Inch Cape Onshore Transmission Works

Regulation 11 Further Application Environmental Impact Assessment (EIA) Report

Document Reference	IC02-INT-EC-ONA-004-INC-RPT-004	
Date	22nd November 2021

The Town and Country Planning (Environmental Impact Assessment) (Scotland) Regulations 2017 – Scoping Opinion under Regulation 17

Figure 1 ELC Proposed Mitigation Seagreen 1A.

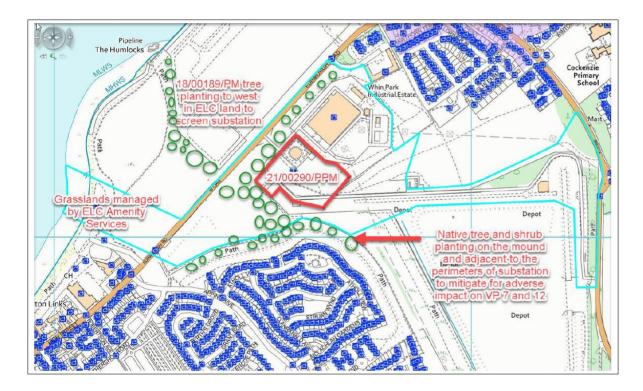
- impact are the proposals to develop a substation to the southwest of the ICOL substation site. The details of the proposed development for Seagreen 1A substation and ancillary electric works can be viewed on ELC planning portal using planning reference 21/00290/PPM. ELCs landscape officer provided comments on this application, including a conceptual landscape plan to help mitigate for the significant landscape and visual impact of the in combination developments. Subject to agreement from all parties, the community, the developers and ELC, the landscape officer believes that planting the existing and proposed earth bunding on both sites will help provide mitigation for the adjacent development. The landscape officer states that bunding and landscape planting could be achieved outwith the redline boundary of the Seagreen 1A site (see Figure 1 below and Appendix 2). The proposed mitigation would be on land managed by ELC and the landscape officer believes there is provisional agreement on this from ELC Amenity Services.

I have attached a copy of landscape comments on adjacent substation development 21/00290/PPM for your information. In particular we draw your attention to Figure 11, which shows a conceptual landscape plan to help mitigate for the significant landscape and visual impact of the in combination developments. Please see attached jpeg titled: Mitigation planting out with site. Subject to agreement from all parties, the community, the developers and ELC, we believe that planting the existing and proposed earth bunding on both sites will help provide mitigation for the adjacent development.

I refer to attached jpeg titled: landscape mitigation 1 of 2 and 2 of 2 [Appendix 2]. [Redacted] and [redacted] have the background on what was discussed and agreed at a management level. The general gist of the agreement is that the bunding and landscape planting could be achieved out with the redline boundary of the site. [we would strongly recommend that you consult ELC Amenity Services] regarding previous agreements to provide 4m high mounds, to be planted with trees and shrubs to the west of the redline boundary. The proposed landscape mitigation will be on land managed by ELC. The previous LVIA generated visuals of these proposals at one year and in year fifteen post construction.

Figure 1.	Except for context, the relevance of these comments to the ICOL proposed Regulation 11 application are unclear. For example, ICOL is unaware of any	bunding on both sites will help provide mitigation for the adjacent development."
		'provisional agreement' with ELC Amenity Services as referenced in the final line of this paragraph – it is understood this relates to the Seagreen 1A proposal.	Following the public inquiry for the original application, Redrock and Marie Adkins and her team including Lindsay Guthrie CMLI from SLR worked with East Lothian to draft landscape mitigation. This
		The ICOL PPP is subject to several conditions, condition 1 of which requires the submission of further details of the substation, including location height and colour. Specifically condition 1(h) relates to landscape and visual mitigation, which must first be discussed with ELC	included landscape mitigation on East Lothian Council land to the south west adjacent to the red line boundary to provide mitigation for the ICOL substation.

Seagreen 1A PPP as the documents associated with that	information on Seagreen as far as this is publicly
		PPP are no longer available on ELCs website. ICOL	available. The case officer will upload the information
		understands that Figure 1 and the commentary in para	to the website once the condition has been signed off

6.41 and Appendix 1 have been included in the ELC	and if it is available at the time of application, it
		Scoping Opinion for context only.	should be included.
		The reference within Figure 1 to tree planting relating	
		to permission 18/00189/PM (the ICOL PPP) is unclear.	
		The location of this planting does not reflect that	
		approved by the ICOL PPP, all of which is within the	
		planning boundary. Further details of this landscape	
		mitigation require to be finalised as required by	
		condition 1(h) of the ICOL PPP (species, details of	
		mounding, maintenance etc). If Regulation 11 planning	
		permission is granted, ICOL would expect a similar	
		requirement for this 'front-end' consultation prior to	
		the submission of these landscape proposals.	
		the submission of these failuscape proposals.	
		It is noted that the EIA Report for the ICOL Regulation	
		11 application will contain an assessment of the

Appendix 1	Sets out ELC landscape	Seagreen 1A application, through reference to the plans approved by that PPP. To the best of our knowledge, Figure 1 does not form part of that PPP. Clarification of these points is requested. Much of the commentary here is repeated within the	See above for comments on why the Landscape
	officer comments on Scoping Request	main body of the Scoping Opinion itself, notably paragraph 6.41. A significant amount of commentary relates to the ELC Landscape Officer comments on the Seagreen 1A application. A number of referenced documents in this Appendix are missing from the Scoping Opinion e.g. reference to Figure 11 in the 4 th paragraph; references to jpeg landscape mitigation 1 of 2 and 2 of 2 etc. There are references to undated discussions and agreements at 'management level' within the 5 th paragraph. ICOL is unaware of what this relates to, or	Officers comments are relevant. Figure 11 referred to in the Landscape Officers comments is Figure 1 reproduced in the Scoping Opinion, which the Landscape Officer also attached as a jpeg, so that is also 'jpeg landscape mitigation'. Jpeg landscape mitigation 1 of 2 and 2 of 2 is the mitigation set out in Appendix 2 of the Scoping Opinion.
